Official Transcript of Proceedings  
NUCLEAR REGULATORY COMMISSION

Title: Advisory Committee on Reactor Safeguards

Date: Wednesday, June 8, 2011

3                   (1)      Opening Remarks by the ACRS Chairman . . . . .	5
4                   (2)      Draft Regulatory Guide DG-1261, . . . . .	6
5                          Conducting Periodic Testing for Breakaway	
6                          Oxidation Behavior; DG-1262, Testing for	
7                          Postquench Ductility; and DG-1263,	
8                          Establishing	
9                          Analytical Limits for	
10                         Zirconium-Based Alloy Cladding	
11                   (3)      Revised Safety Evaluation Report	
12                          Associated with the License Renewal	
13                          Application for the Hope Creek	
14                          Generating Station . . . . .	81
15                   (4)      Commission Paper on Level 3 Probabilistic	
16                          Risk Assessment Activities . . . . .	117
17                   (5)      NRC Bulletin 2011-01, Mitigating

# **“Acceptable experimental techniques” to measure ductile-to-brittle transition for the zirconium-alloy cladding material**

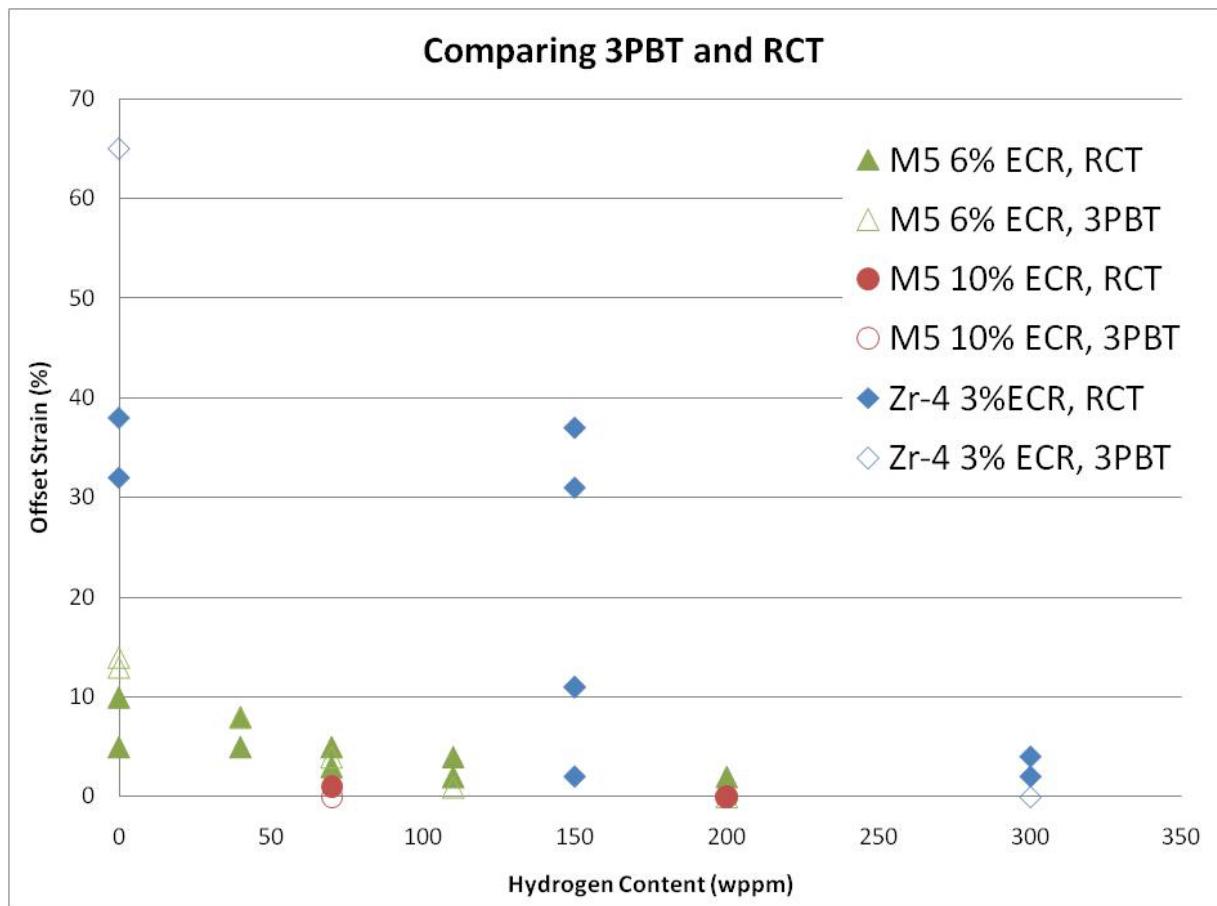
4 CHAIRMAN ABDEL-KHALIK: I'm just asking a  
5 question that pertains to the data that's shown in  
6 this table.

1       the fuel would be on and the three point bend test is  
2       closer to what loading. And I was hoping that the  
3       data would show that the ring compression test is  
4       conservative. But in a couple of these things it is  
5       conservative. But others it's not.

1 MEMBER ARMIJO: Right. But on the  
2 previous slide you're making a statement that ring  
3 compression testing and three point bend testing has  
4 been shown to yield comparable results. And that's  
5 the reasons for these questions.

on Michelle's slide 12 which compared the rate compression test to three point bend test. And a quick comment is that these are, as Bill Shack correctly pointed out, offset strains. And the brittle-to-ductile transition is 2.0 percent offset strain for the ring compression test. So all four values listed are below that. They're in the --

9                  MR. CLIFFORD: Well, I'm sure the Office  
10      of Research can expand upon this. But there's nothing  
11      to say that the criterion used to judge the ductile-  
12      to-brittle transition which in this case would be 1.0  
13      percent plastic for ring compression is the correct  
14      transition point for three point bend test.

17                  MR. CLIFFORD: -- in the reg. guide but we  
18      accept the 1.0 percent as the figure of merit to mark  
19      the ductile-to-brittle transition married with ring  
20      compression test. That's what we're saying in our  
21      reg. guide. If the industry was to come in and say,  
22      "I don't want to use that reg. guide. I'm going to  
23      come up with my own experimental technique using three  
24      point bending," then the onus would be on them to  
25      define what that transition point should be.

# Drywell Air Gap at Azimuth 225°

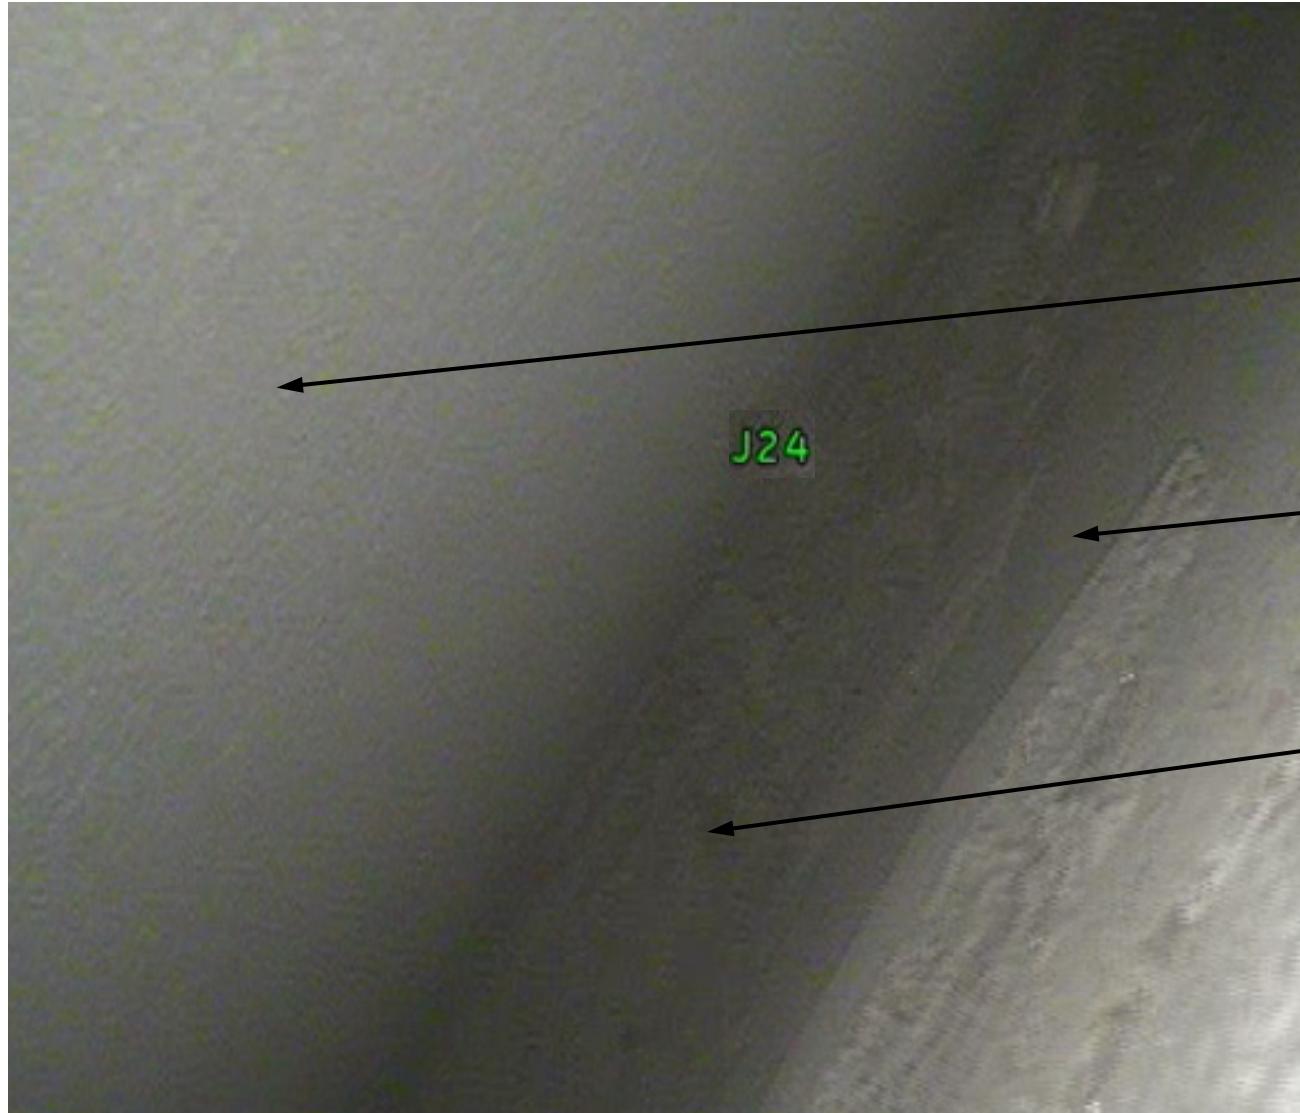
17                  MEMBER STETKAR: Just for clarification,  
18                  Jim, if you go back to what I hope I can say this  
19                  time, slide 7. We're looking at the point where that  
20                  arrow says bottom of dry well air gap. Is that  
21                  correct?

22                  MR. STAVELY: That is correct.
